To: Maine Forest Service Garage Renovation Jonesboro Plan Holders

RE: Addendum 1:

TYPICAL BASE PLATE REPAIR

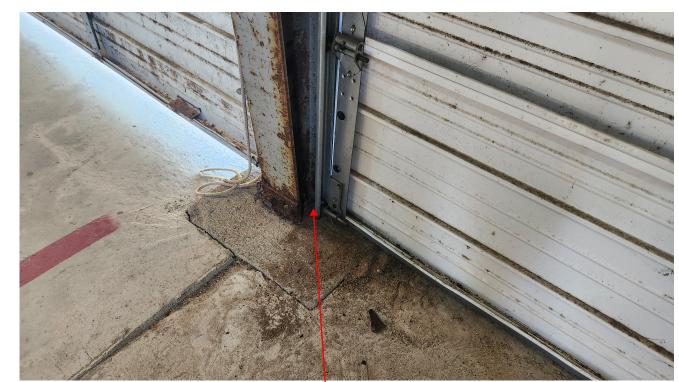
See attached revised bid form, and Base of Frame Repair Sketch. The sketch applies to all frame bases, typical.

Work described in the sketch shall be bid as Alternate 3.

G.C. TO VERIFY
SOUNDNESS OF
ANCHOR BOLT AND TO
NOTIFY E.O.R.. IF
- ANCHOR IS NOT TO BE
RE-USED, CORE DRILL
EXIST ANCHOR ROD
WITH 1" DIAM. BIT TO
REMOVE

1. G.C. TO SHORE THE EXISTING FRAMES PRIOR TO REMOVAL OF ANCHORAGE. REPAIRS SHOULD BE MADE AT (1) SINGLE FRAME AT A TIME AND SHORING (1) SINGLE FRAME AT A TIME.

2. G.C. TO NOTFIY ENGINEER OF ANY DISCREPANIES OF THE EXISTNG STRUCTURE PRIOR TO START OF REPAIRS.
